Nomination Form  
Anadromous Waters Catalog

Name of Waterway Herring Cove Creek  USGS Name  Local Name  
 Addition  Deletion  Correction  Backup Information

**HERRING COVE CREEK**

**ROUTE CORRECTION**

Figure 1.—Lower portion of the bedrock cascade barrier on Herring Cove Creek.

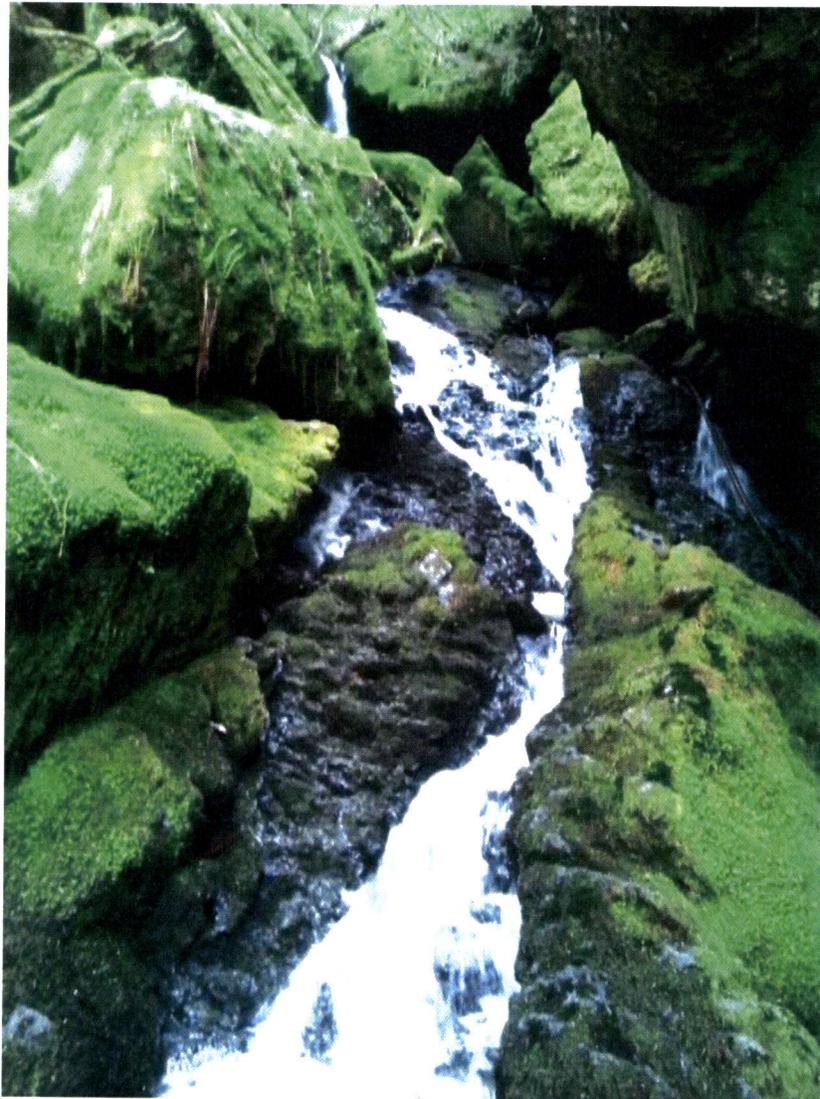
Waypoint	Latitude	Longitude	Notes	Sample Effort	Sample Results
177	55.3266	-131.5292	High tide mark, trib entering on RL.		
178	55.3263	-131.5297		HN	2 CO
179	55.3266	-131.5305		EF	3 CO
180	55.3265	-131.5307	Seep that is providing half the flows on RR. Only 10' long so not tracking.		
181	55.3265	-131.5308	Calling it the top. Water is just seeping out of th ground.		
182	55.3271	-131.5284	Back on Herring Cove creek.		
183	55.3276	-131.5319	Trib RR, ends in seep.		
184	55.3283	-131.5342	Cataloged upper limit is correct. Long bedrock cascade before a tall falls.

Figure 2.— Herring Cove Creek Route Correction map.

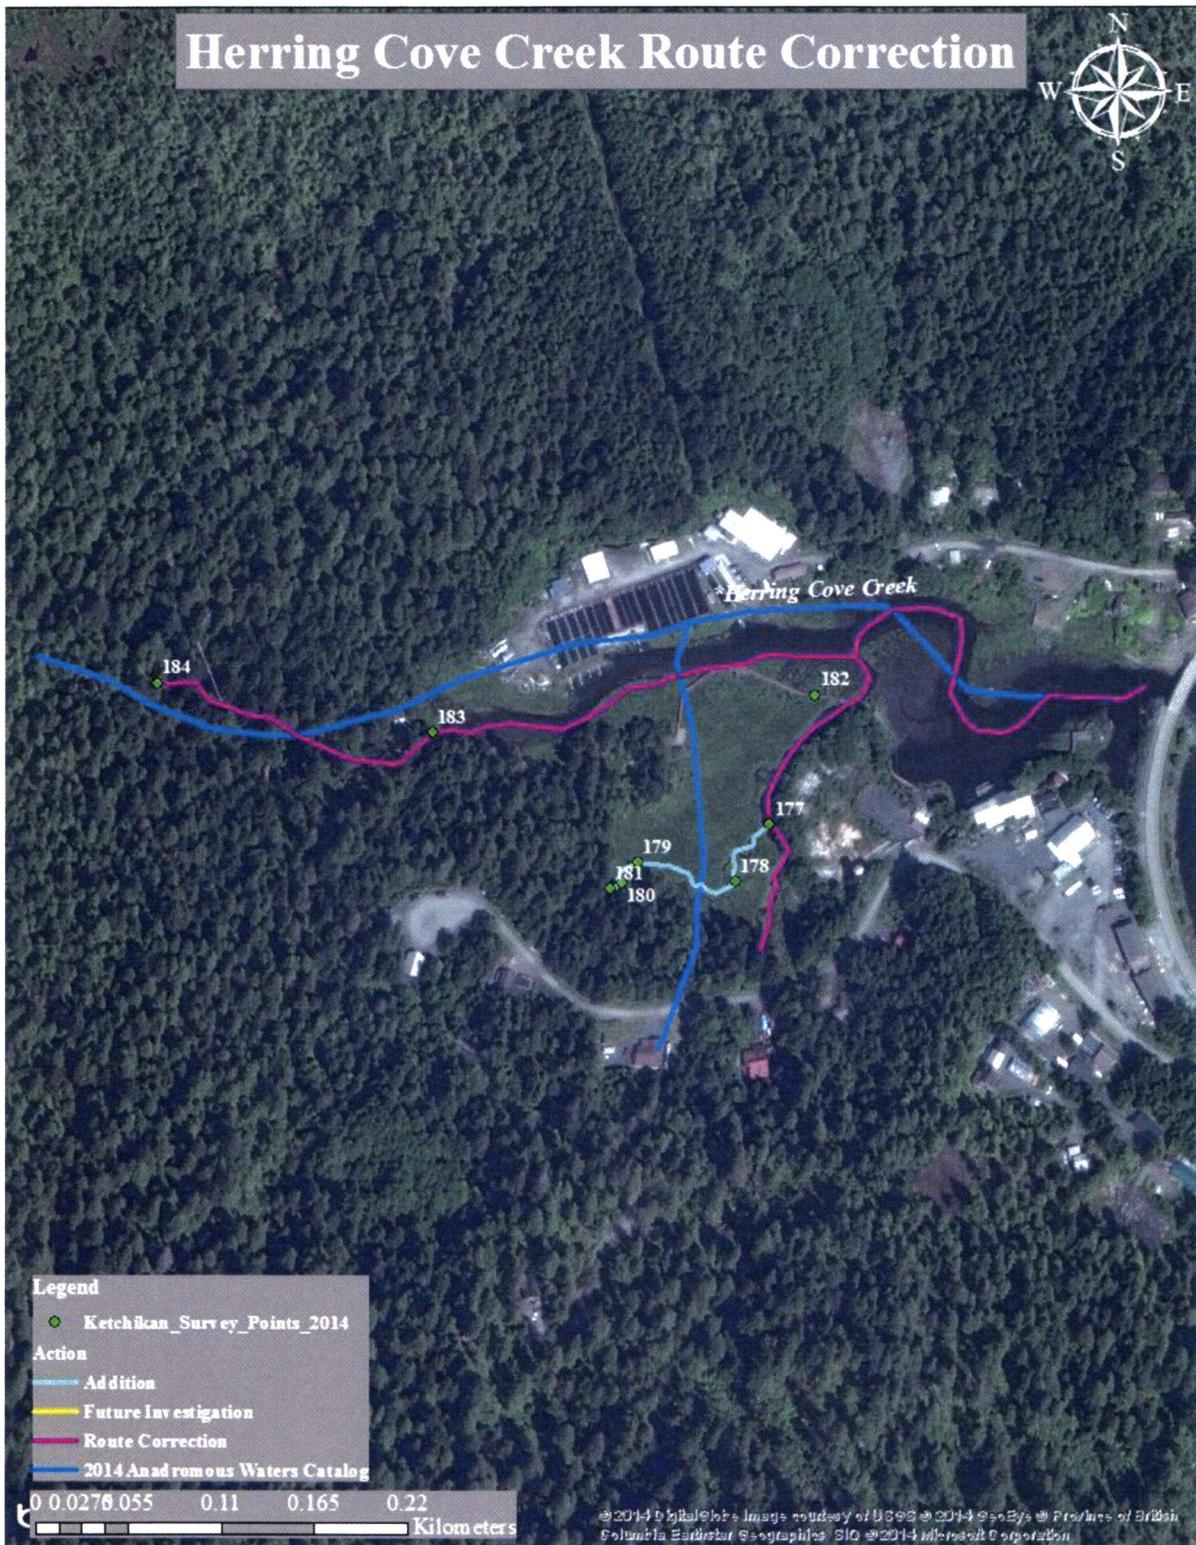
Please update this stream's route in the AWC to reflect the field-verified course.  
 Coordinates (Lat,Long): Upper(55.3283,-131.5342) Lower(55.3266,-131.5254)  
Hydrography changes made in conjunction  
with addition of new stream 101-45-10070-2011-2012

**Findings:** This stream's cataloged route differs from the field-verified route.

**Recommendations:** Please update this stream's course to reflect the field-verified route and maintain species currently cataloged.
